BOBCAT OF NEW HAMPSHIRE

SITE PLAN APPLICATION # 11-21

STAFF REPORT #3

Re: Town of Hudson Planning Board Review
Bobcat of NH's Site Plan, 2 Rebel Road & 345 Derry Road
Tax Map 101 Lot 18 & 19; Acct. #1350-977
Reference No. 20030249.2080

DUMPSTER ENCLOSURE - VINYL

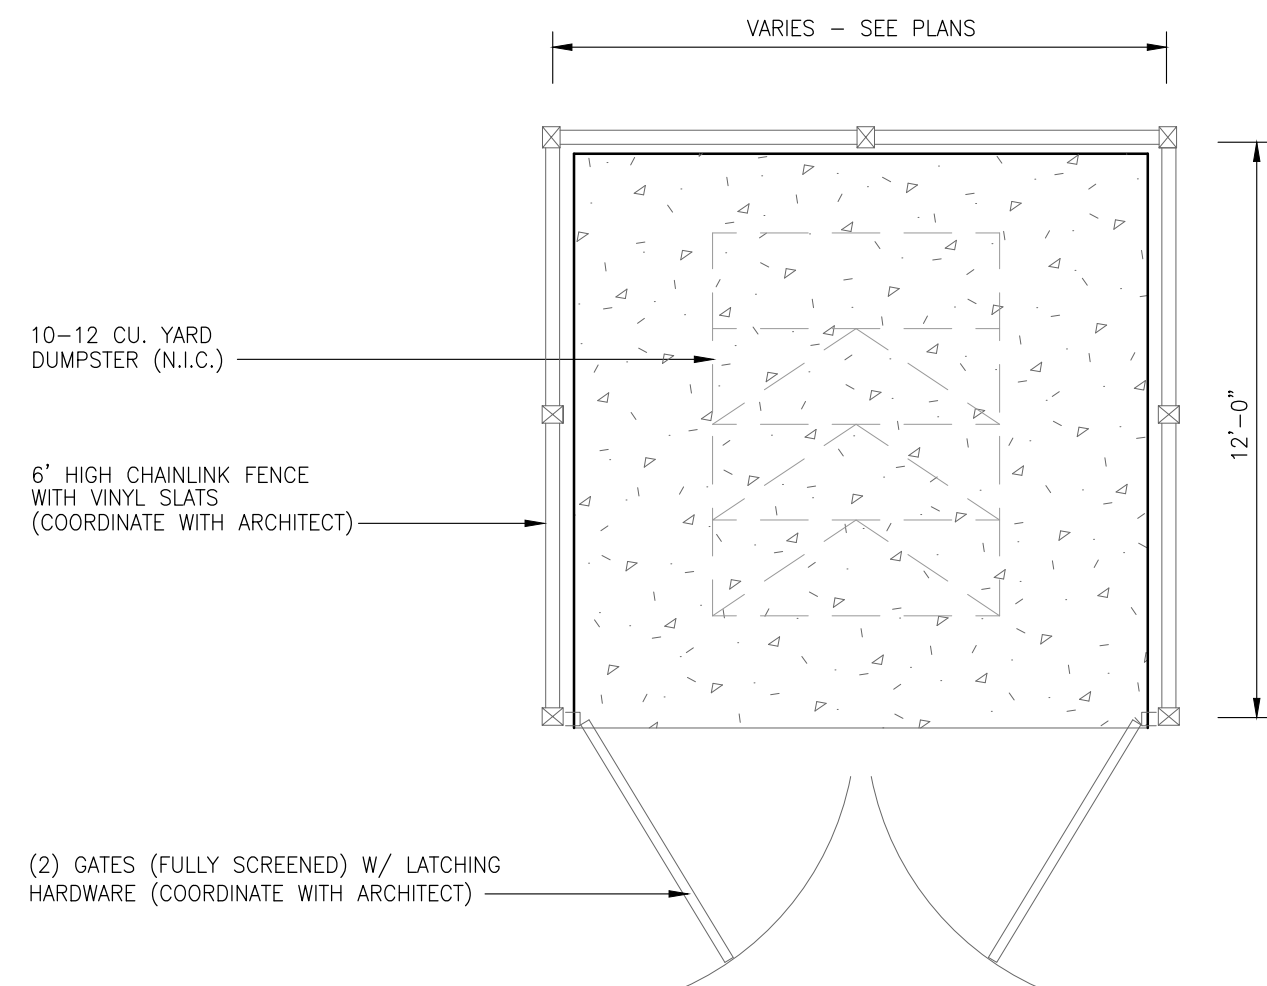
- a. *Former Fuss & O'Neill Comment: The applicant should review the need for an enclosure around the dumpster at lot 19.*
Current Fuss & O'Neill Comment: The applicant has added a dumpster enclosure and detail to the plan set. No further Fuss & O'Neill comment.

OUTLET STRUCTURE 1

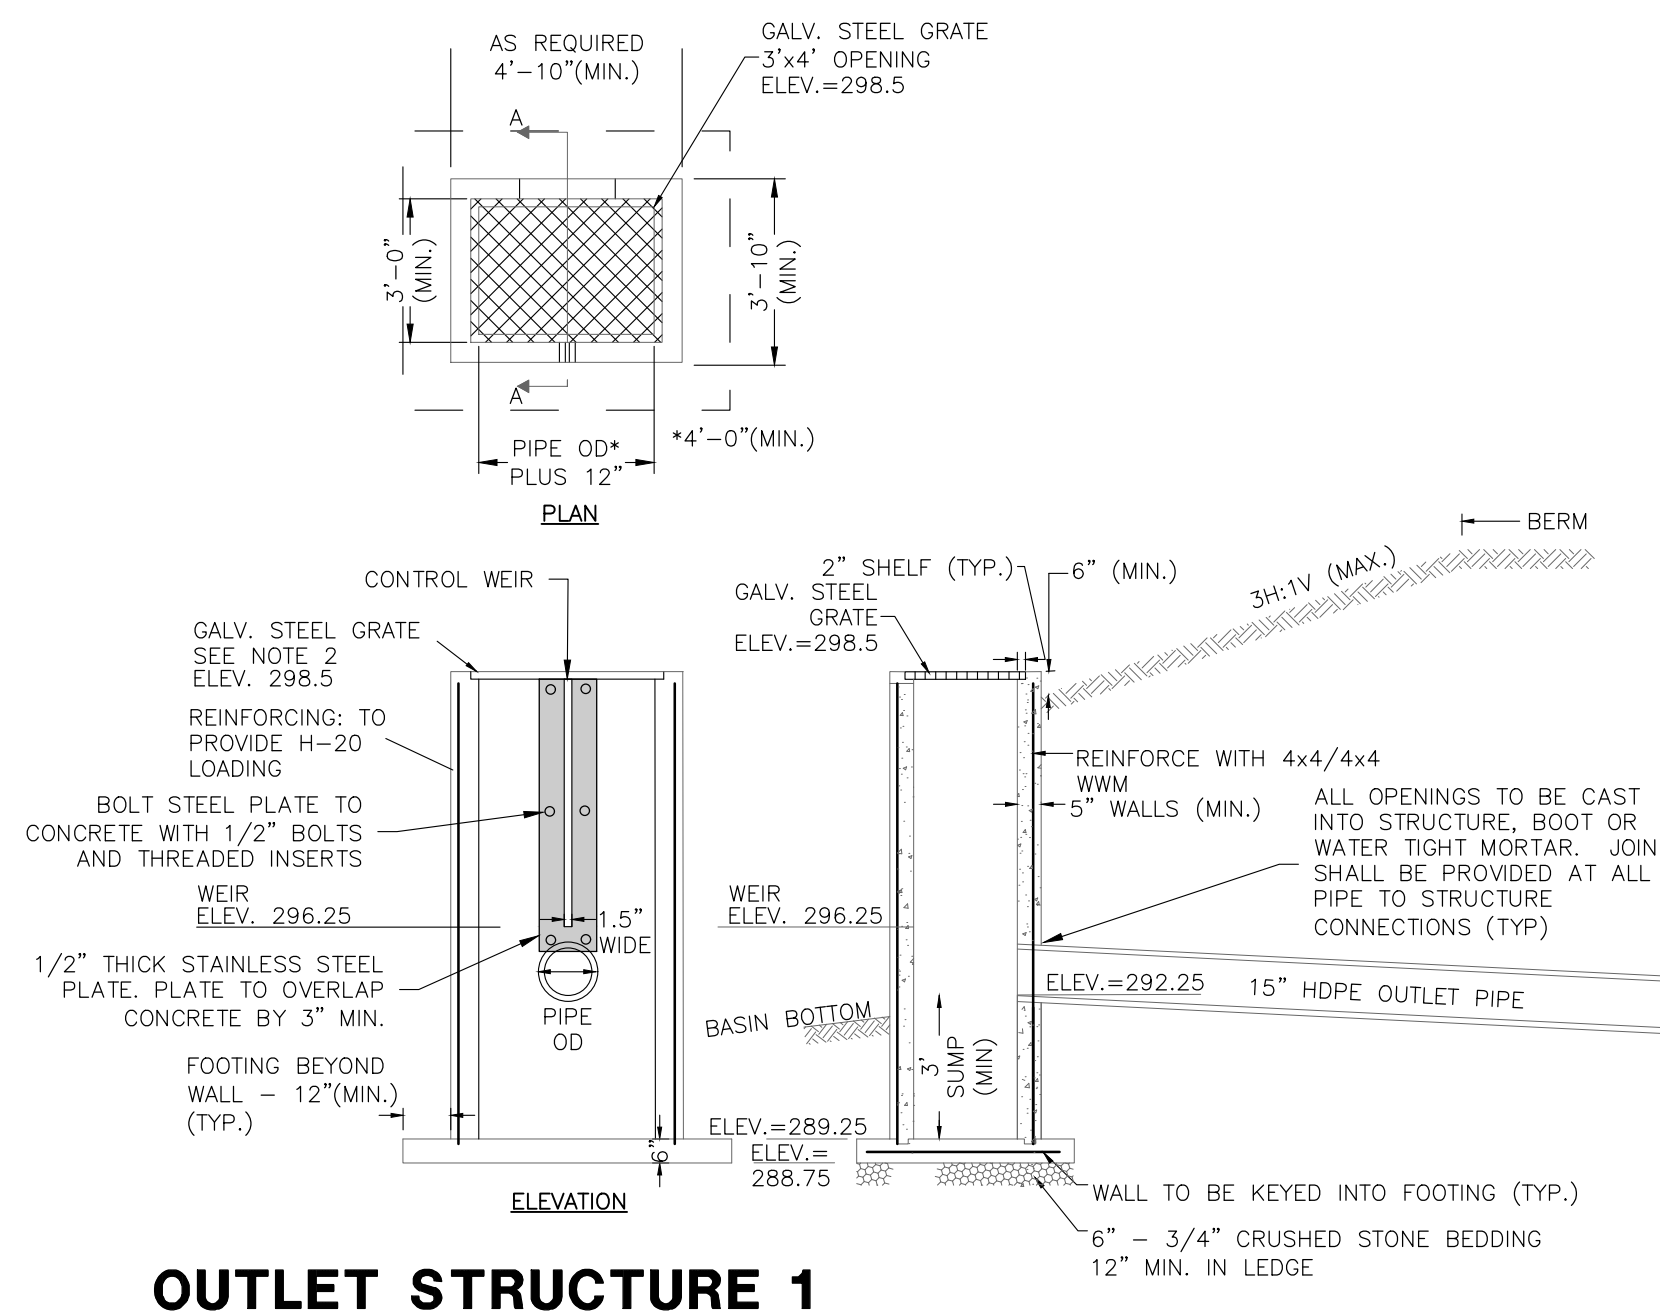
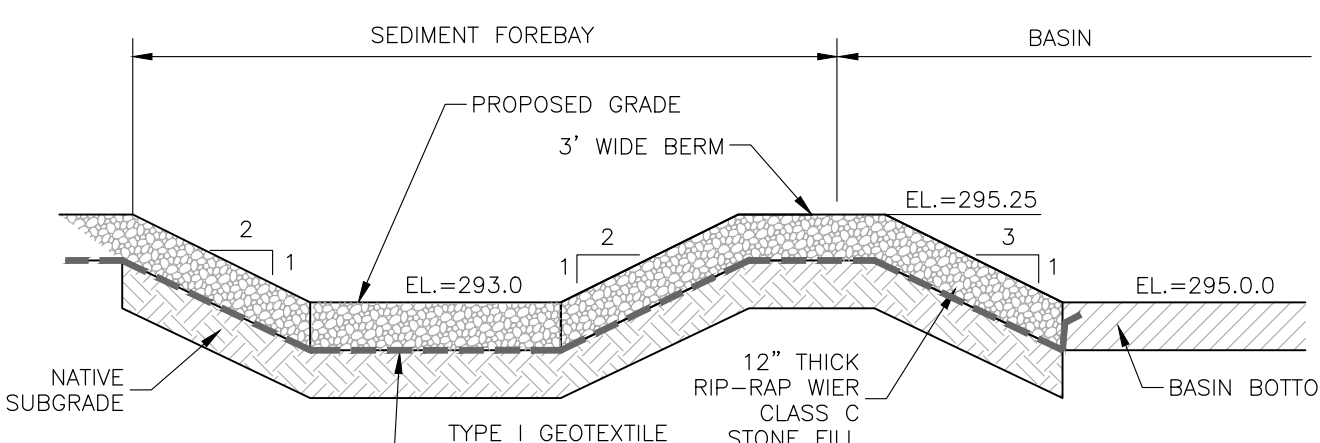
- l. *Former Fuss & O'Neill Comment: ETGTD 930.3. The Outlet Structure Detail on Plan Sheet C-11 illustrates a 3'x4' galvanized top grate, while the Stormwater Report for Pond 201P illustrates a 30"x42". The applicant should correct this discrepancy.*
Current Fuss & O'Neill Comment: The applicant has revised the Stormwater Report and pond 201P to a 3'x4' grate size. The applicant should provide revised stormwater calculations illustrating the revised grate sizing.
- m. *Former Fuss & O'Neill Comment: ETGTD 930.4. We note that the two proposed stormwater pipes utilize a pipe slope less than the required 2.0%. The applicant should illustrate how the drain line velocities are self-cleaning.*
Current Fuss & O'Neill Comment: The applicant has revised the pipe slopes to 2.0%. The applicant should provide revised stormwater calculations illustrating the revised pipe slopes.

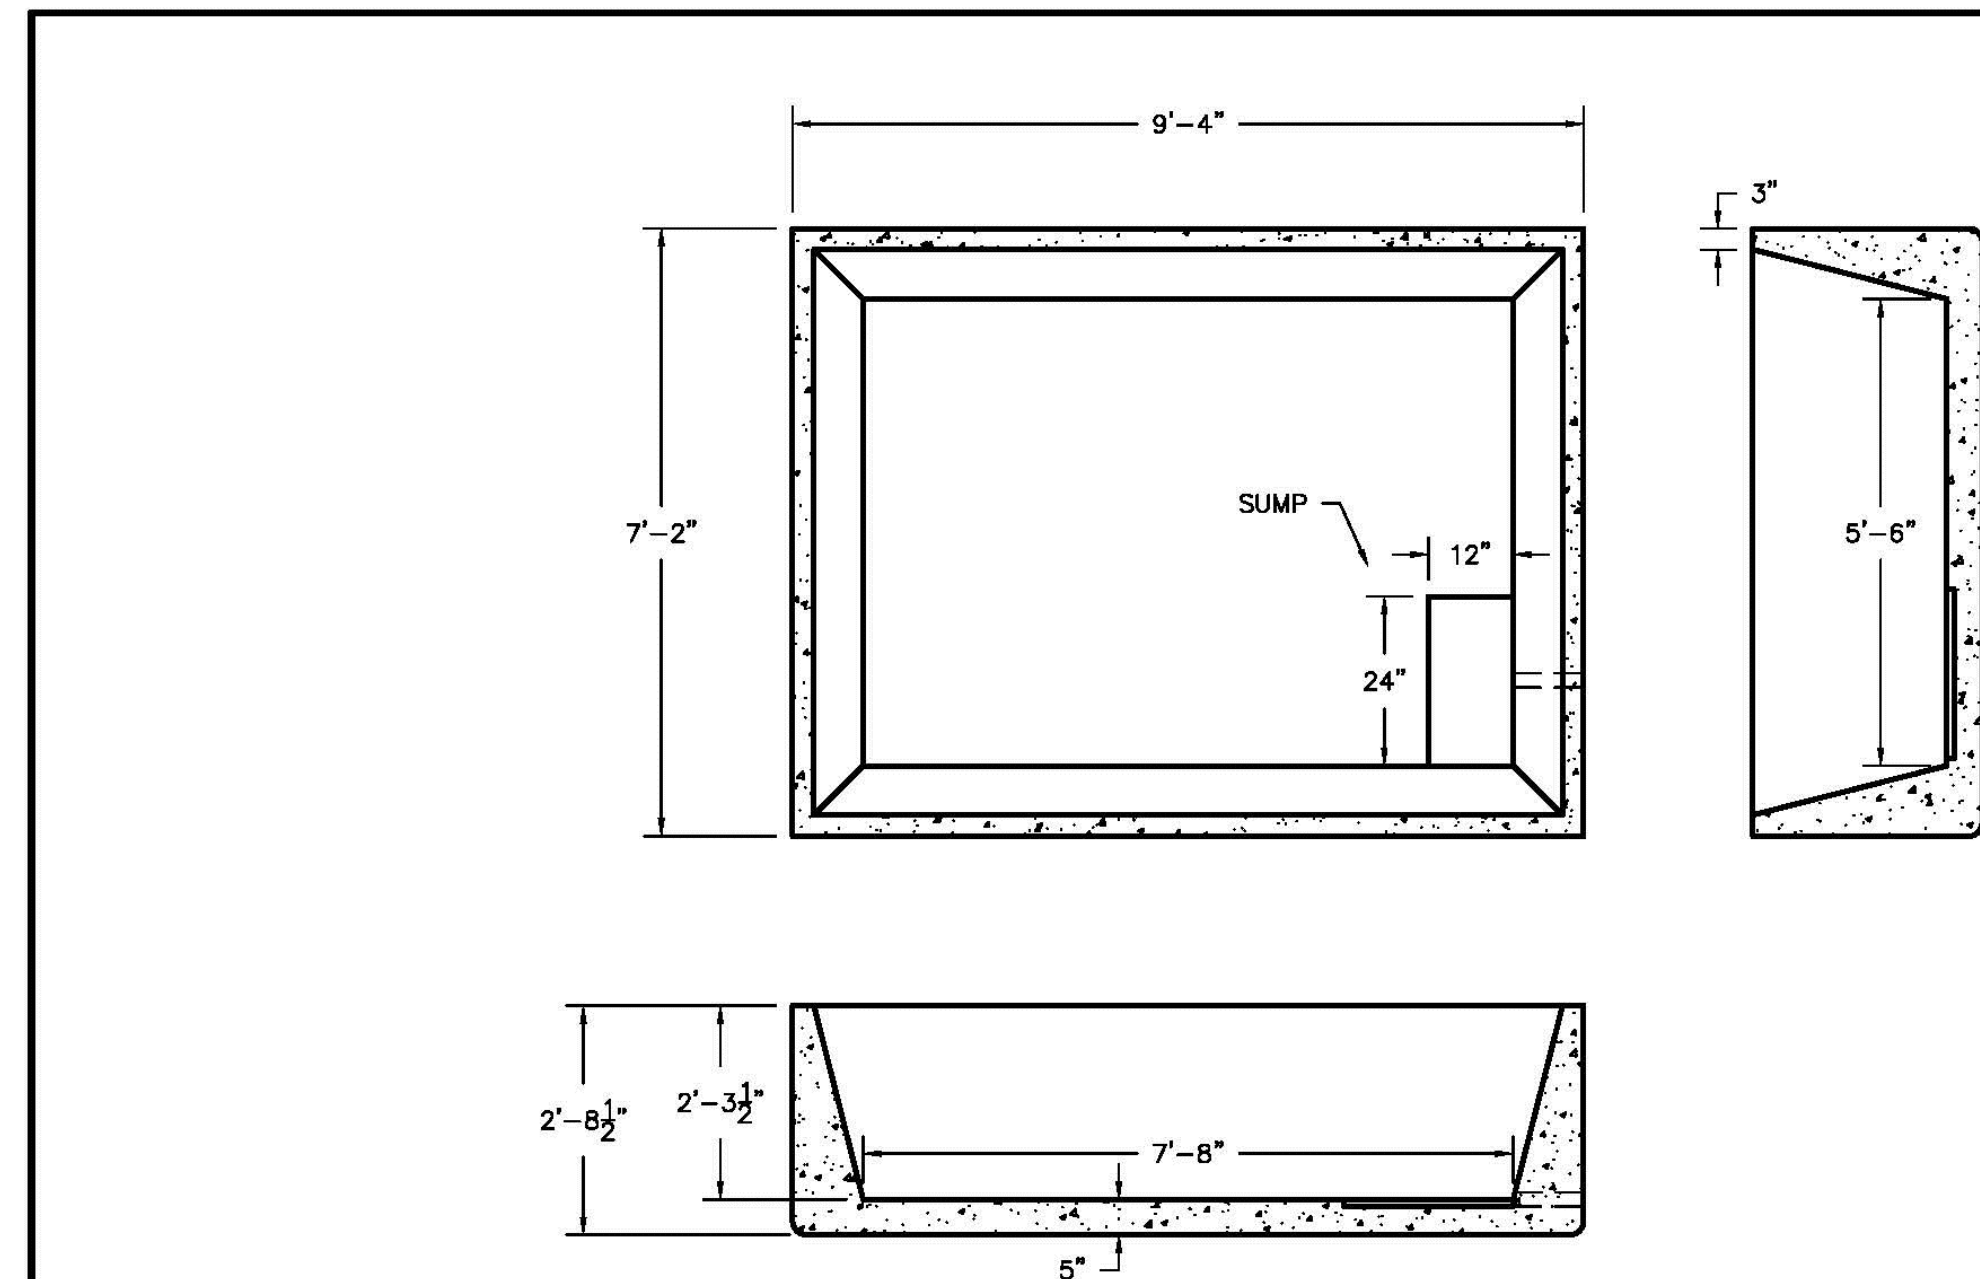
- d. *Former Fuss & O'Neill Comment: The applicant should confirm if a permit is required for the fuel/oil storage tanks proposed for lot 19 and provide a detail on the plans for the spill containment slab.*
Current Fuss & O'Neill Comment: The applicant has noted that registration of the above ground storage tanks is not required by the NHDES for tanks with a storage capacity less than 1,320 gallons. Although the plan does not specifically note the size of

the proposed tanks, the applicant has provided a detail for containment vessels for 550-gallon tanks. The applicant should confirm the proposed tank sizes.
